Access Compliance Report

Public Rights-of-Way

(Curb Ramps)

Intersection ID: 10029218	Main Street: JOHNSON AND WALES_WY	Cross Street: N/A	Location: W
ADA ID: BD485364ED85	Ramp Type: Perp	Initial Pass/Fail: Fail	Overall Compliance: No
Severity Score: 12.5			
Codes/Mitigation Info/Possible Solution		Field Measurements/Component Compliance

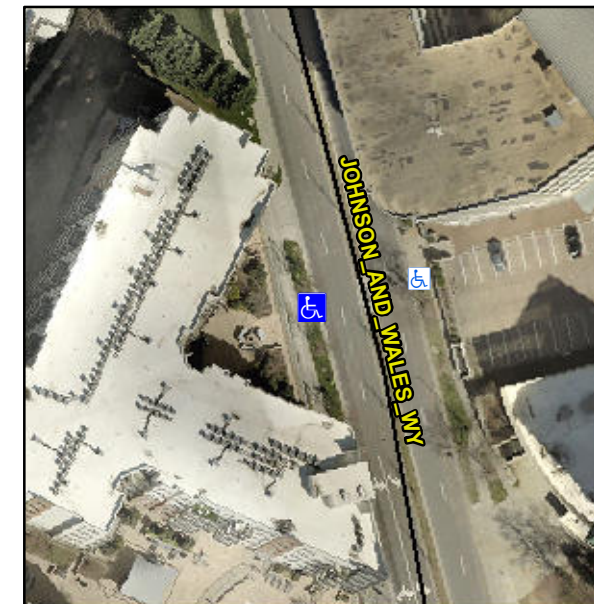
Not Found, R304.5.3

Compliance	Description	Data	Compliance	Description	Data
N/A	Ramp Length (in)	96.5	Yes	Ramp Slope (%)	7.3
Yes	Ramp Width (in)	71.0	No	Ramp XSlope (%)	6.4
N/A	Flare Type LT	N/A	N/A	Flare Type RT	N/A
N/A	Flare Slope LT (%)	N/A	N/A	Flare Slope RT (%)	N/A
N/A	Flare Traversable LT?	N/A	N/A	Flare Traversable RT?	N/A
N/A	Landing Length (in)	N/A	N/A	DWS Provided?	N/A
N/A	Landing Width (in)	N/A	N/A	DWS Contrast?	N/A
N/A	Landing Slope (%)	N/A	N/A	DWS Length (in)	N/A
N/A	Landing X Slope (%)	N/A	N/A	DWS Full Width?	N/A
N/A	Landing Curb? (Y/N)	N/A	N/A	DWS Offset (in)	N/A
N/A	Shared Landing?	N/A			
N/A	Gutter Ponding?	N/A	N/A	Gutter Slope (%)	N/A
N/A	Gutter Lip Ht (in)	N/A	N/A	Gutter X Slope (%)	N/A
N/A	Painted X Walk1?	No	N/A	Painted X Walk2?	N/A
	X Walk 1 Direction	To E		X Walk 2 Direction	N/A
N/A	X Walk 1 Width (in)	N/A	N/A	X Walk 2 Width (in)	N/A
	X Walk 1 Slope (%)	4.4		X Walk 2 Slope (%)	N/A
	X Walk 1 X Slope (%)	3.2		X Walk 2 X Slope (%)	N/A

Remove & Replace Entire Ramp.
